WestConnex

M4-M5 Link

Submissions and
Preferred Infrastructure Report

Response to community submissions

Figure C4-1 Indicative spoil haulage route for Darley Road civil and tunnel site (C4)

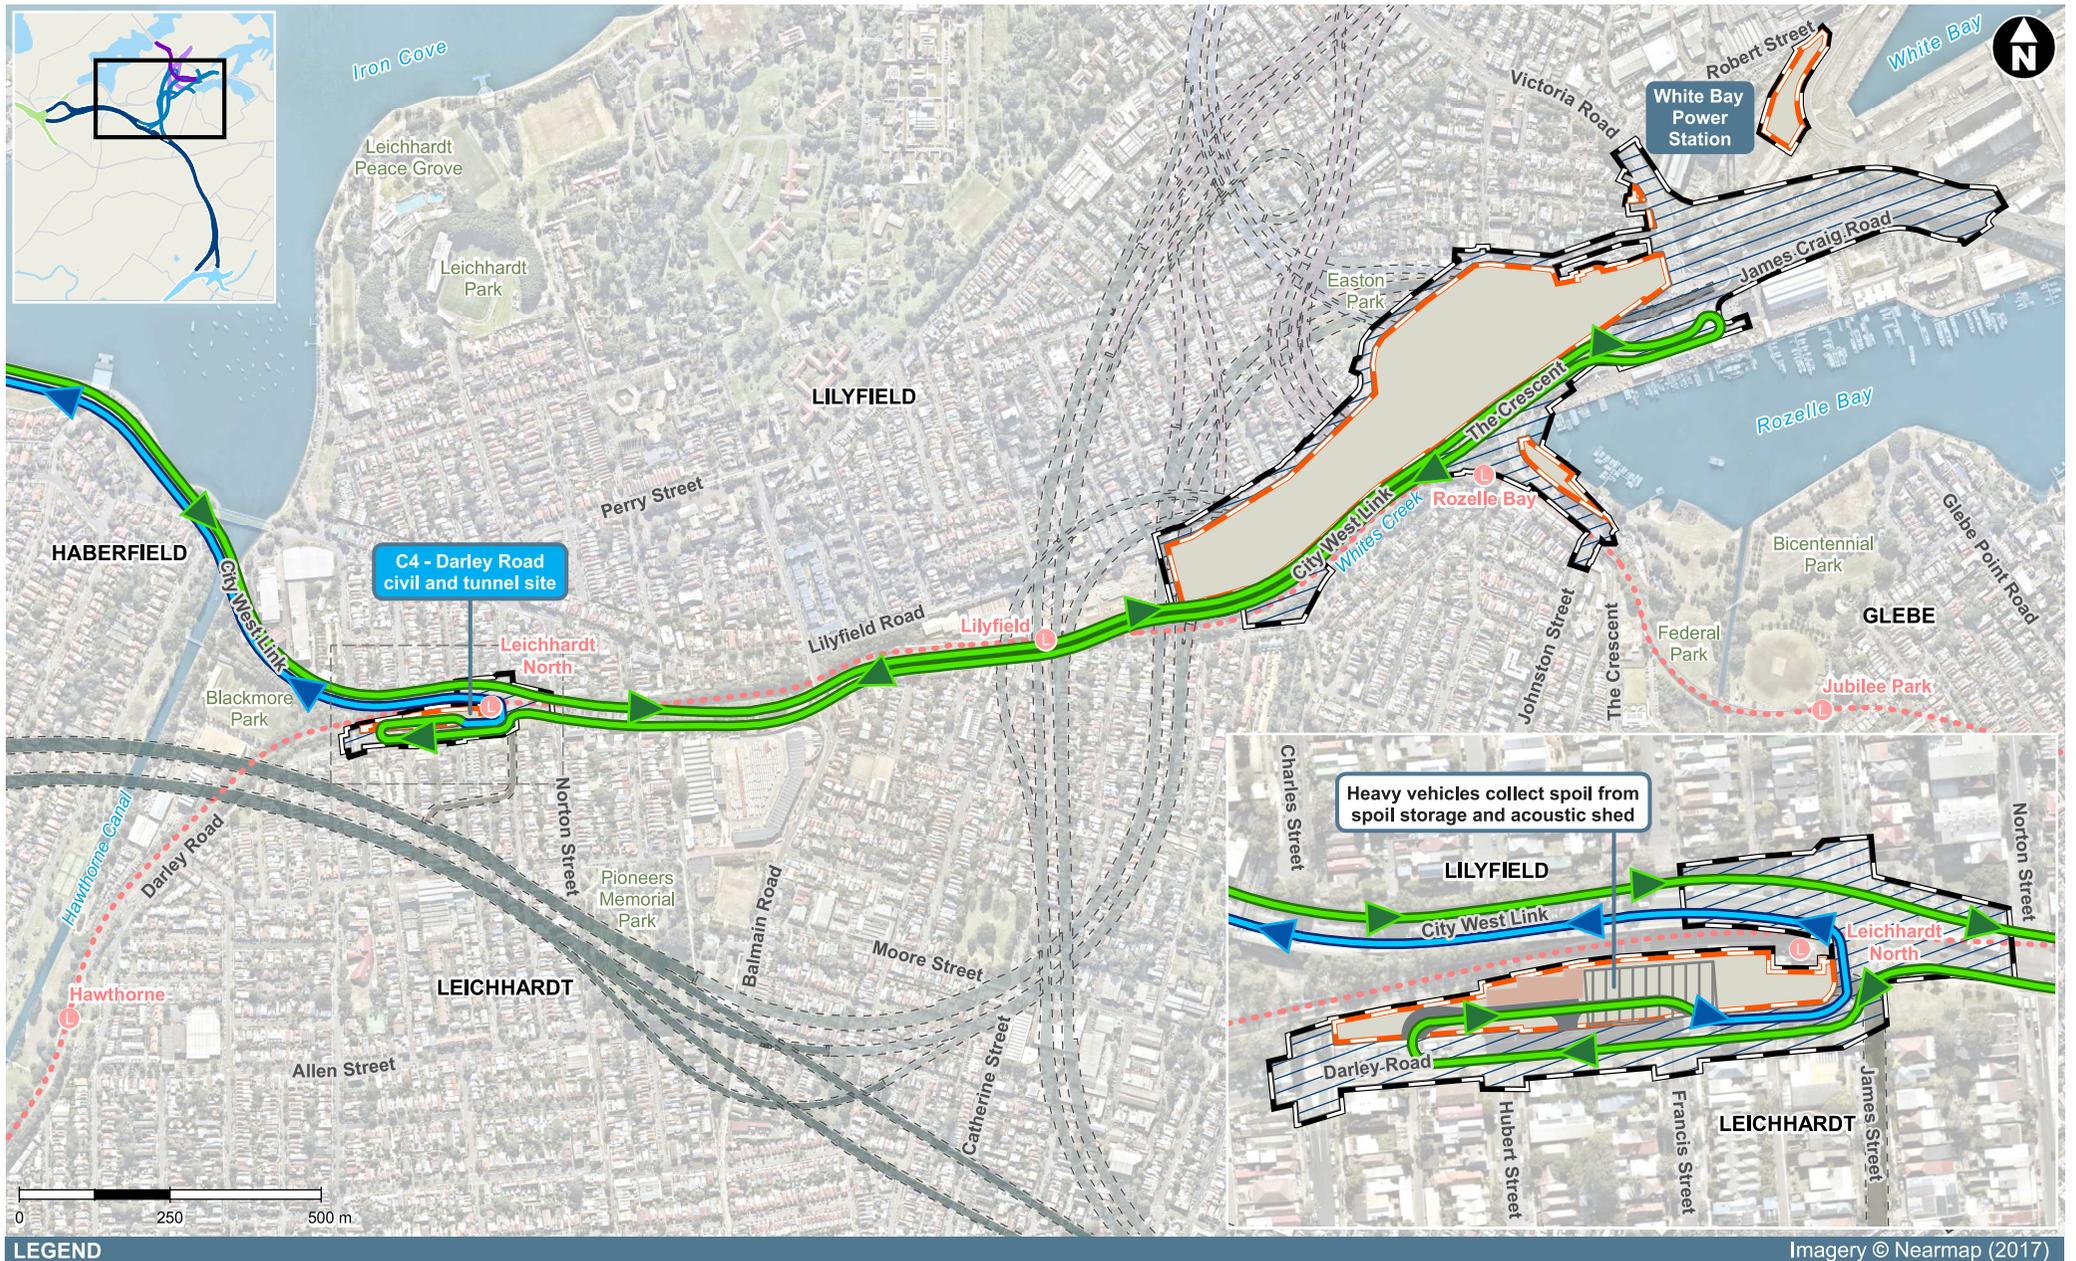
The option of using City West Link for access to the Darley Road civil and tunnel site was investigated (see **section B11.6.9** for further information). While this option would remove heavy vehicle spoil traffic from Darley Road, it was not supported for the following reasons:

The design changes would provide opportunities to reduce potential traffic and noise impacts while minimising physical changes to the EIS design. The indicative new construction haulage route is shown in **Figure C4-1**.

The indicative program for the Darley Road civil and tunnel site (C4) is shown in Table 6-12 of the EIS and in **Table C6-1**. Heavy vehicles would enter and exit the site according to the updated haulage route in **Figure C4-1**. Heavy vehicles would turn right from Darley Road to enter the site then travel east within the site before turning left to exit the site onto Darley Road and complicated manoeuvring would not be required.
